# Compton Community College District 1111 E. Artesia Blvd. Compton, CA 90221

- PROJECT: RFQ CCC-088 VAPA
- SUBJECT: ADDENDUM #1

# COMPTON COMMUNITY COLLEGE DISTRICT RFQ CCC-088 Visual and Performing Arts (VAPA)

### COMPTON COLLEGE STRUCTURAL UPGRADE OF REMAINING PORTIONS OF EXISTING BUILDING Y ADDENDUM 1 CONSOLIDATED CHANGES NARRATIVES

SHEET TITLE INTERIOR FINISH MATERIALS SHEET NUMBER
	A610

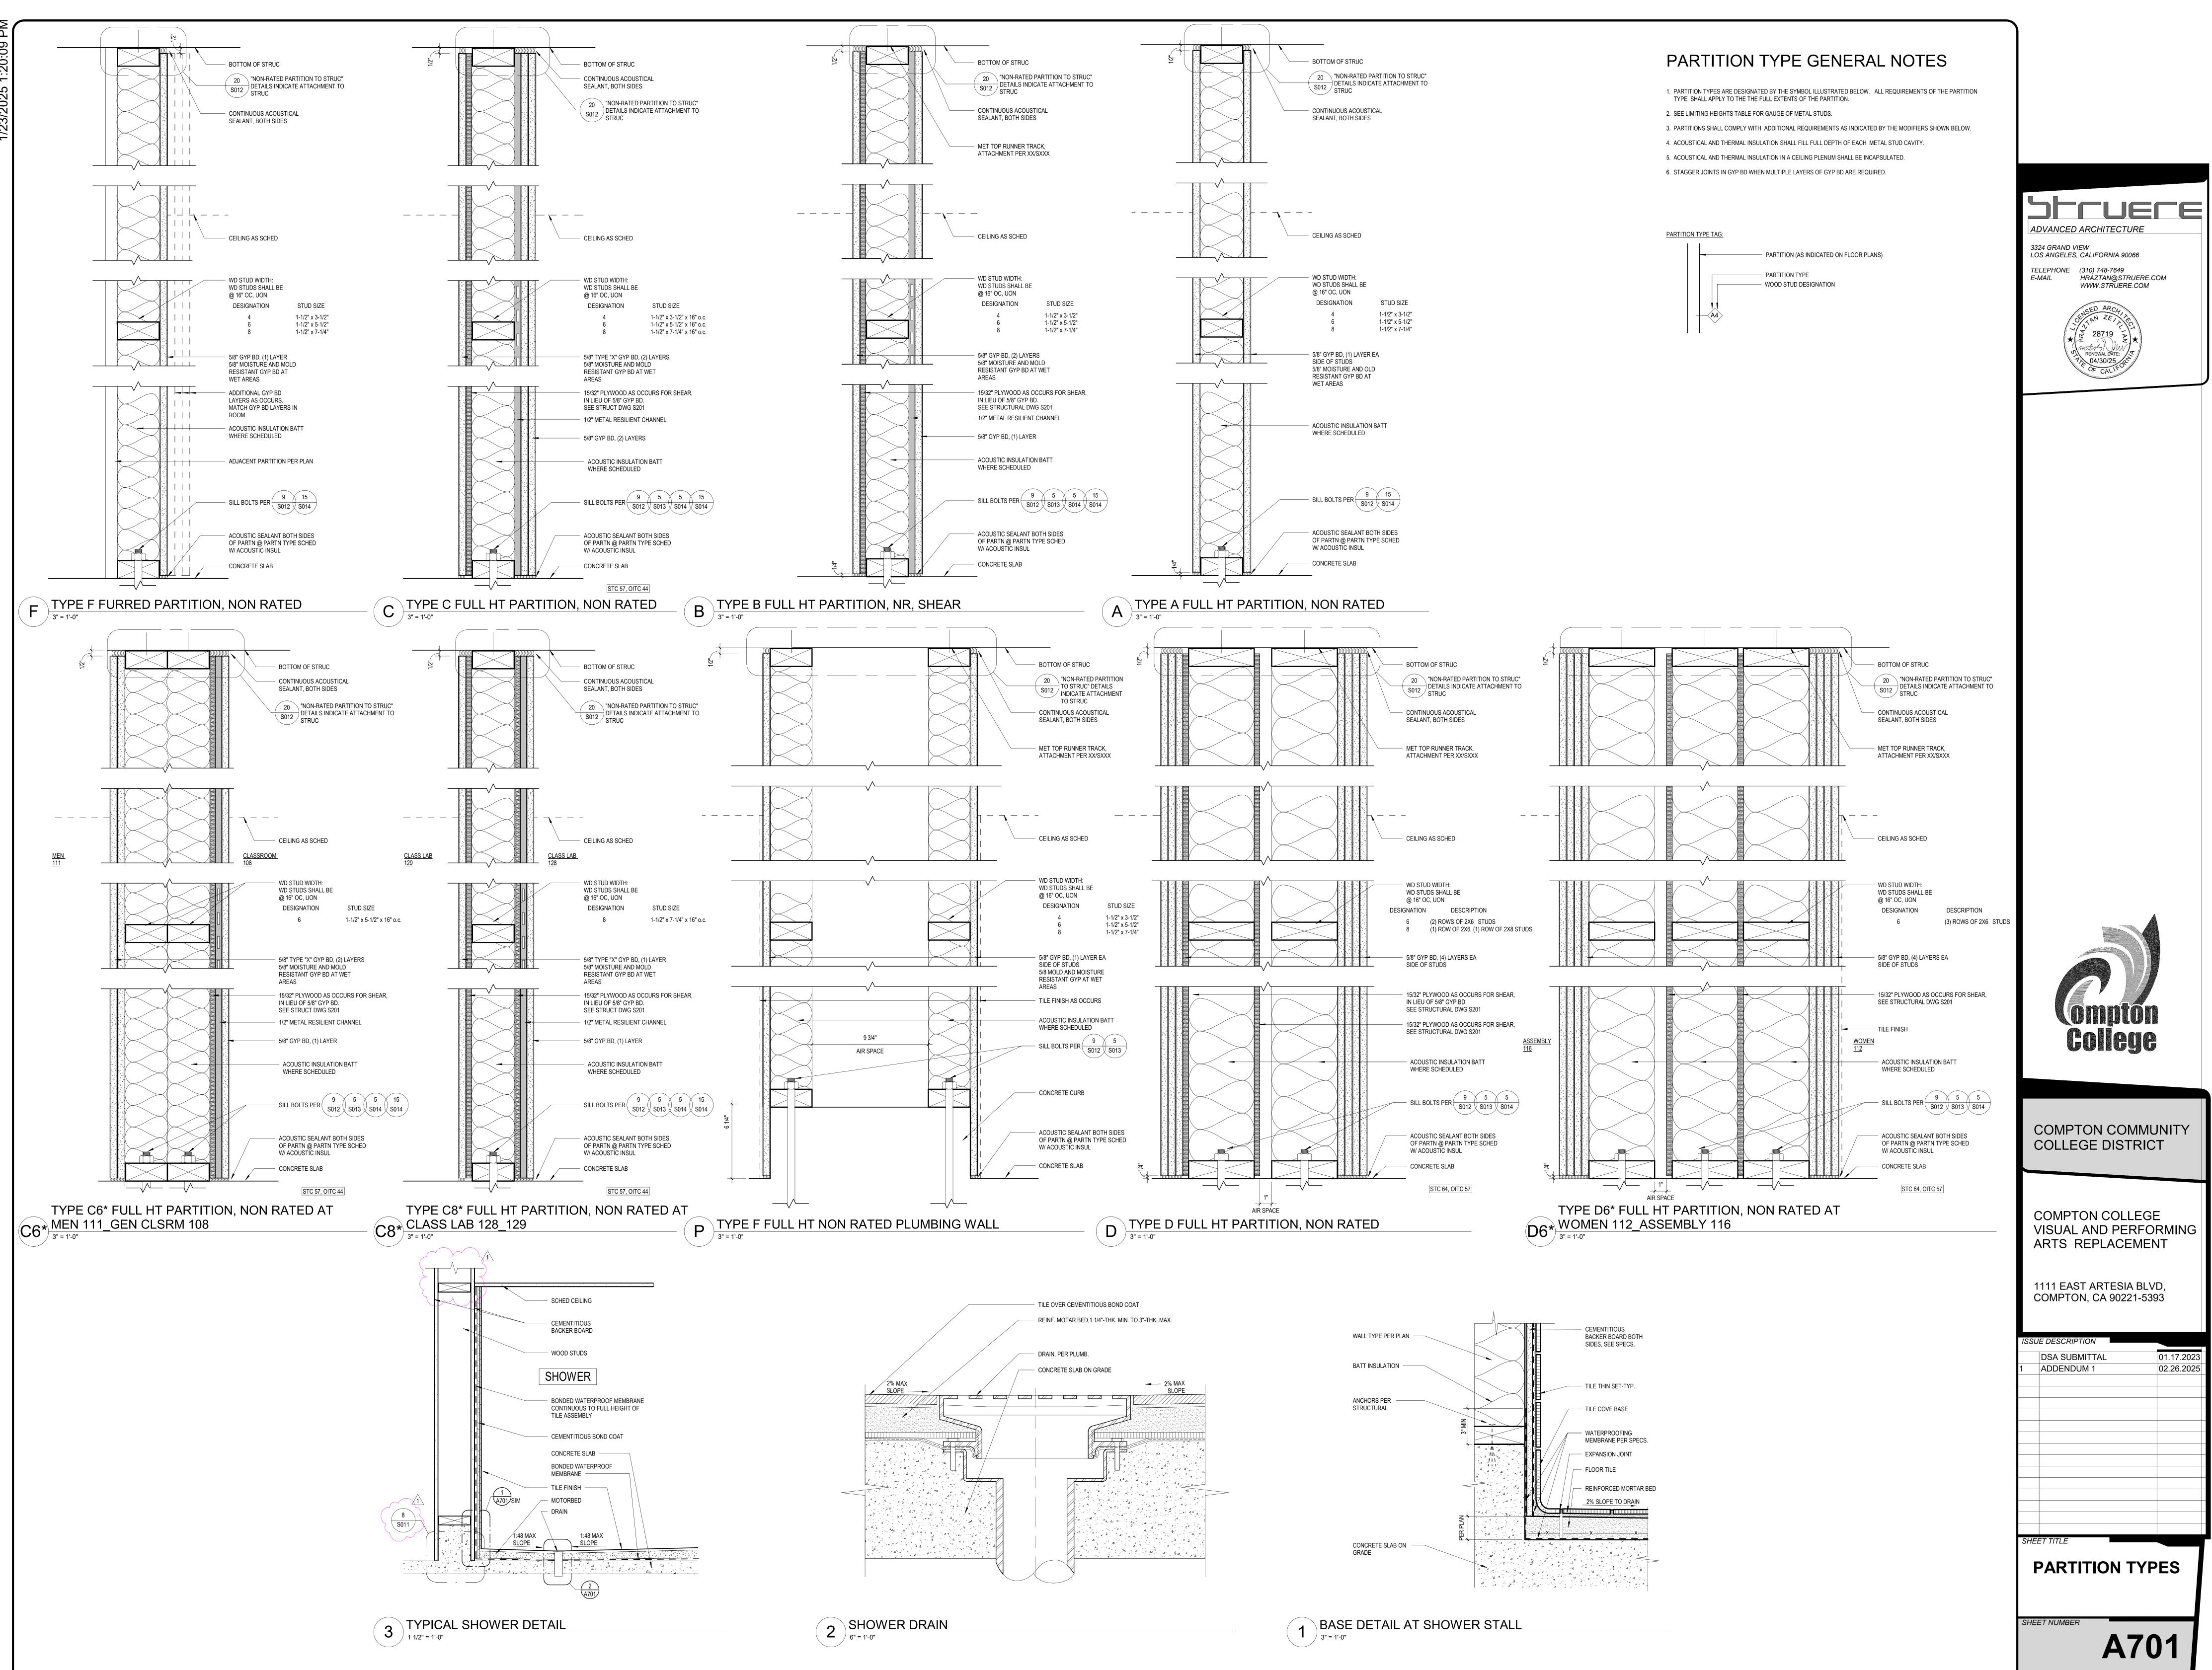
8	Doors with adjacent side lights, will the entire opening need to match the doors STC rating?		Div 08	Yes, revised drawings will be issued by addendum. (Struere)

E102

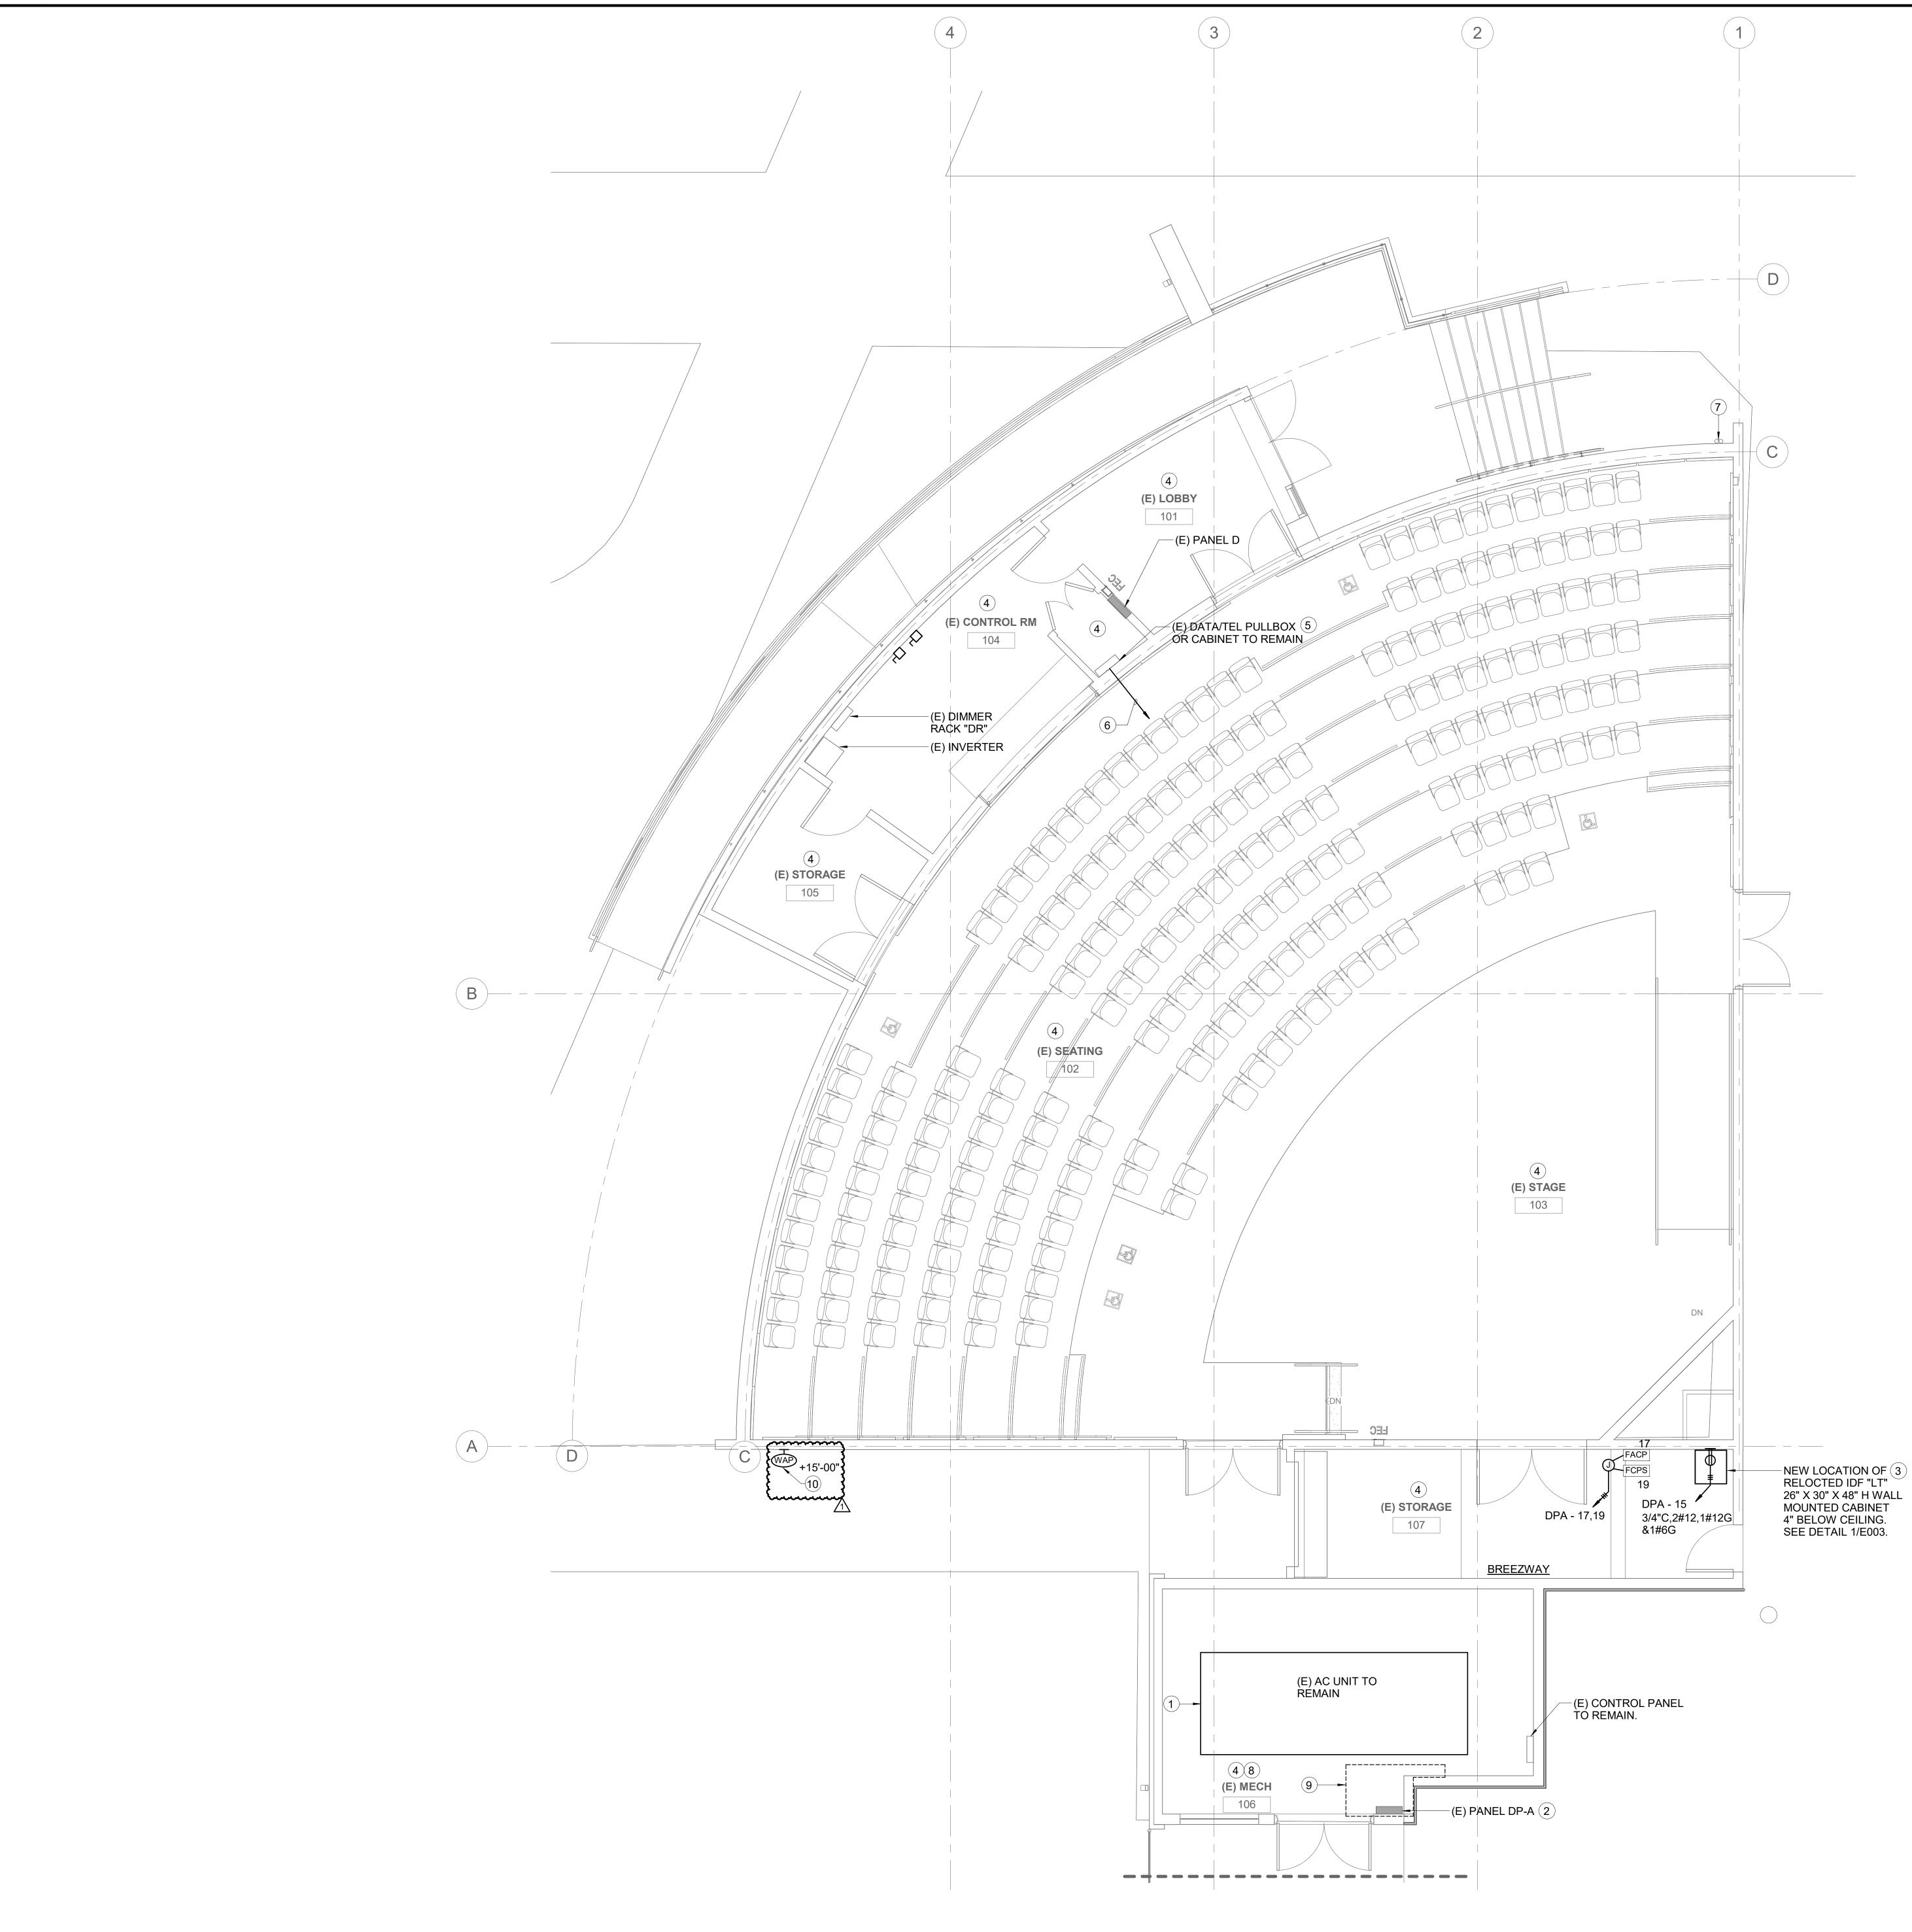
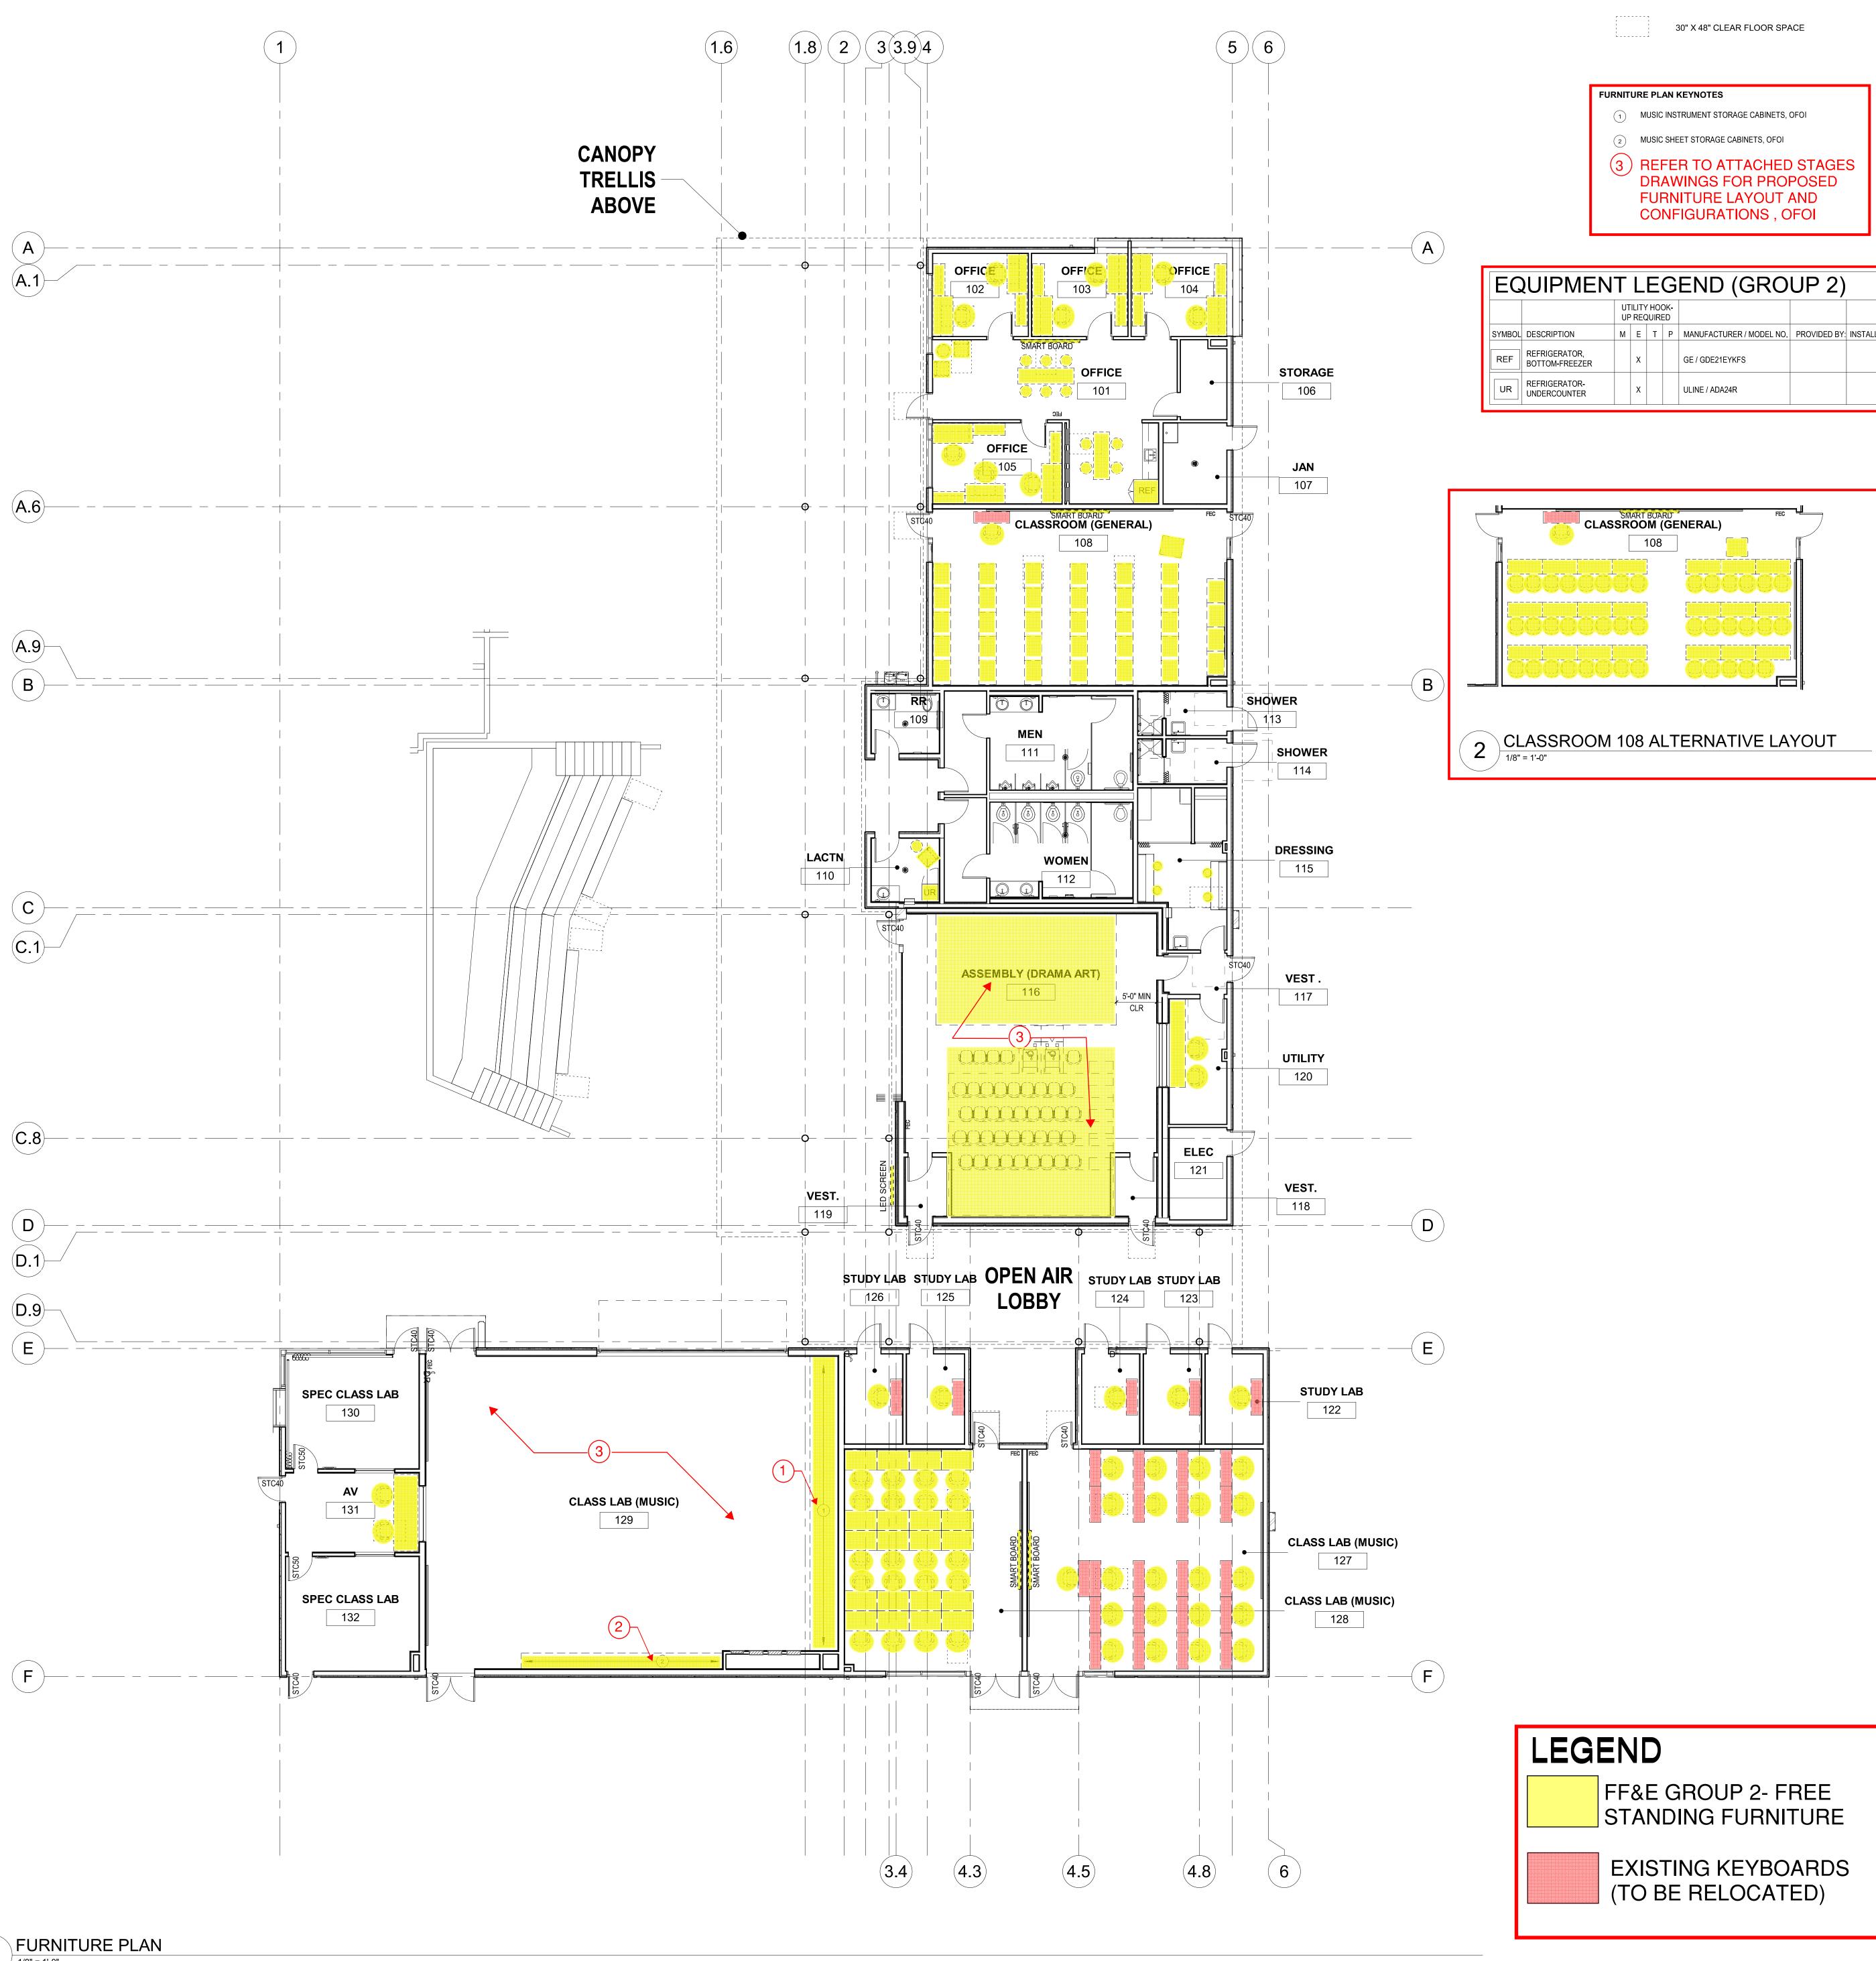
ELECTRICAL	
E001 - ELECTRICAL FRONT SHEET	Wall mounted WAP added to symbols legend.
E302 - ELECTRICAL POWER FLOOR PLAN	Added power to new SmartBoard added on the north wall of OFFICE 101
E303 - ELECTRICAL SIGNAL FLOOR PLAN	5 wall mounted WAP's added.
